有關運輸署對 A/YL-KTS/1060 的查詢

Appendix 2
Location: DD 106 Lot 480 (Part)

Proposed Temporary Warehouse (excluding
Dangerous Goods Godown) with Ancillary
Facilities for a Period of 3 Years

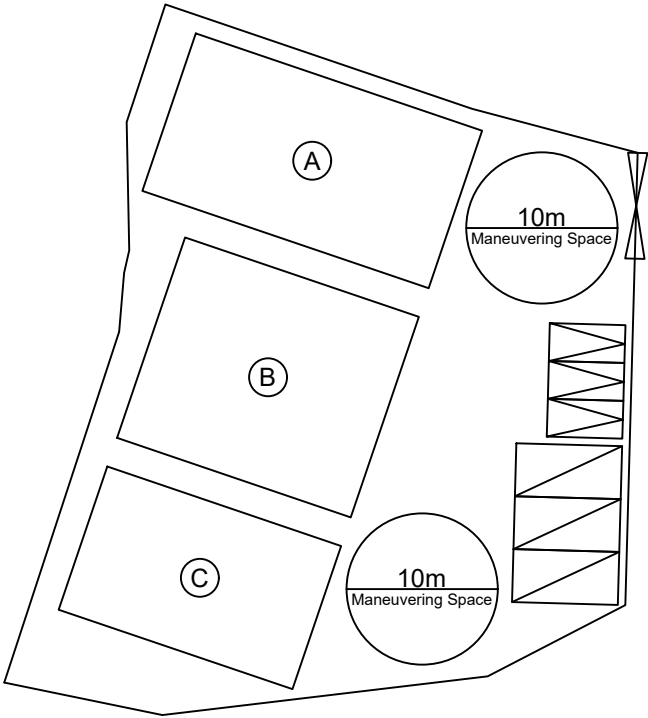
收悉 貴署對 A/YL-KTS/1060 申請的疑問，本人現書面回覆。

進入本申請地點的人士可使用錦上路，再以小徑進入申請地點。錦上路為一條雙線雙程的道路，設計容量為每小時 800 輛車輛。本申請的車流量少，不會對附近交通造成負面影響。此外，小徑的闊度上大多數能足夠讓兩輛平排通過，闊約 5-6 米，私家車及客貨車有足夠的位置通過及進行調動。

申請地點的出入口約 7 米闊。
